TVA-11-422A+ PCN Report

AN-60-079

COMPARISON PERFORMANCE CURVES^a:

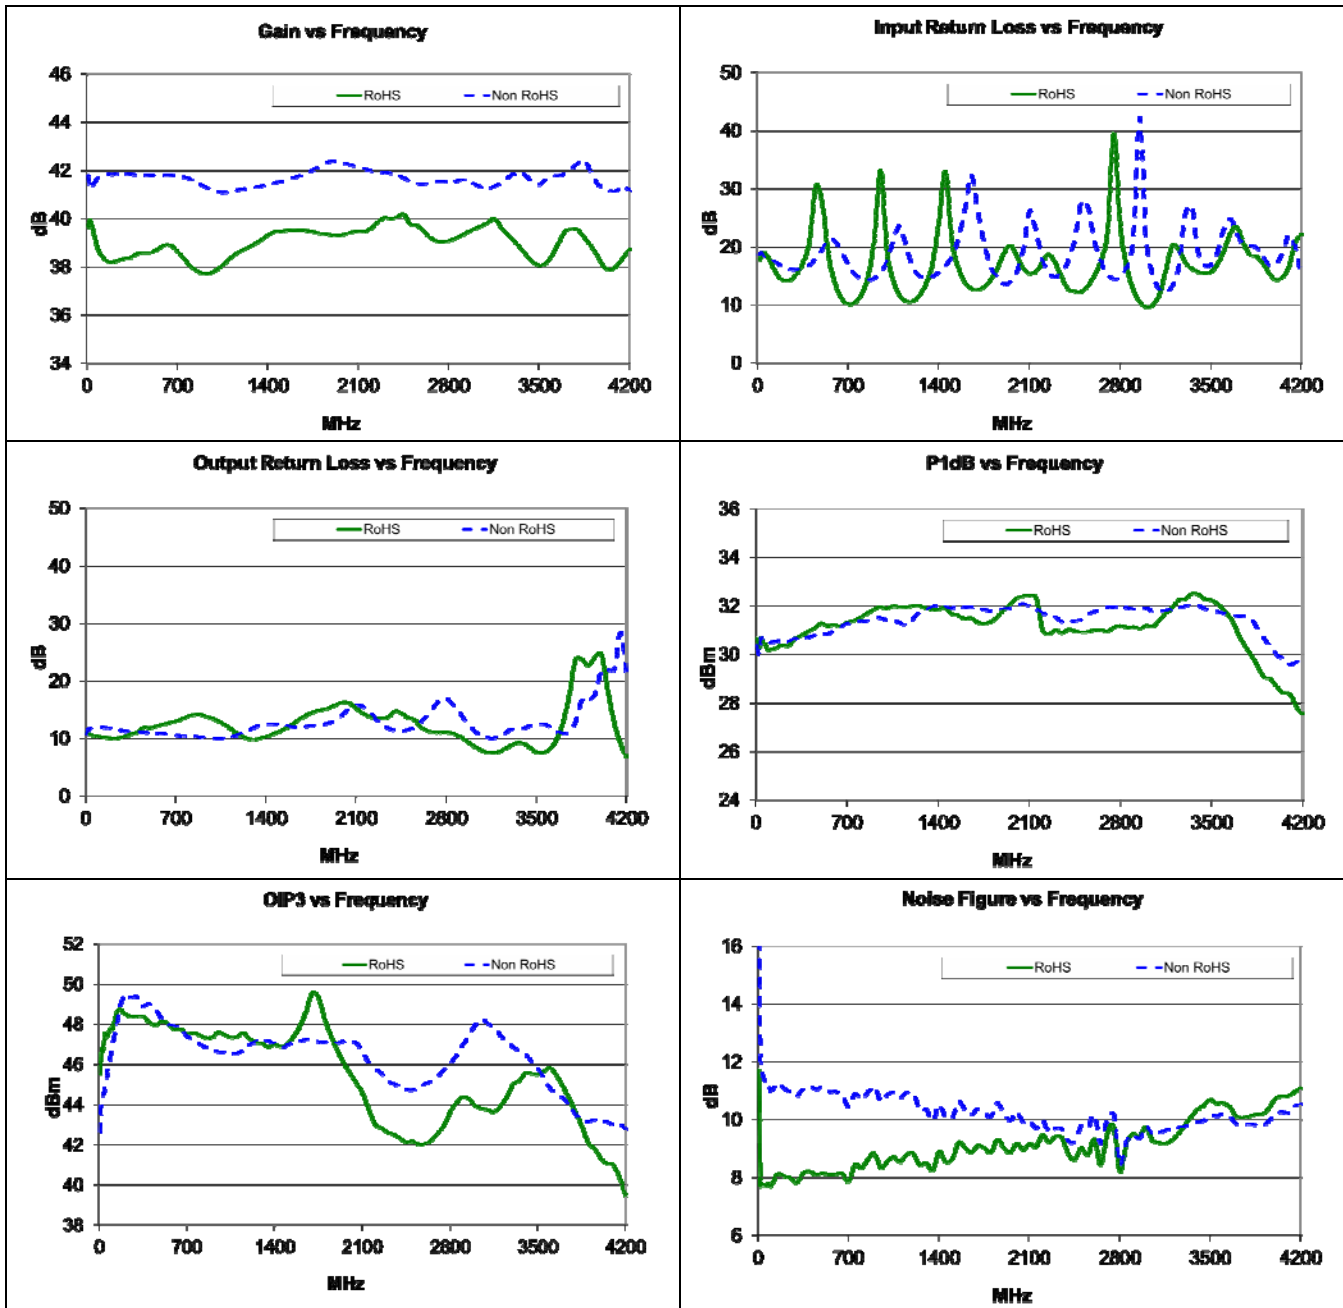
3) TYPICAL PERFORMANCE COMPARISON_a: T_{AMB}=25°C

Parameter	Freq (MHz)	Non RoHS (TVA-11-422)		RoHS (TVA-11-422A+)	
		Data of 1 unit		Data of 2 units	
		Min	Max	Min	Max
Gain (dB)	10-4200	41.11	42.39	37.61	40.17
Gain Flatness (dB)	10-4200	-----	+/-0.64	-----	+/-1.28
Input VSWR (:1)	10-4200	-----	1.56	-----	2.53
Output VSWR (:1)	10-4200	-----	1.92	-----	2.72
P1dB (dBm)	10-3600	30.36	-----	30.04	-----
	3600-4200	29.68	-----	27.53	-----
OIP3 (dBm)	10-4200	42.63	-----	38.47	-----
Noise Figure (dB)	10-4200	-----	16.18	-----	12.7
AC Supply (V)	-----	-----	110/220	-----	110/220
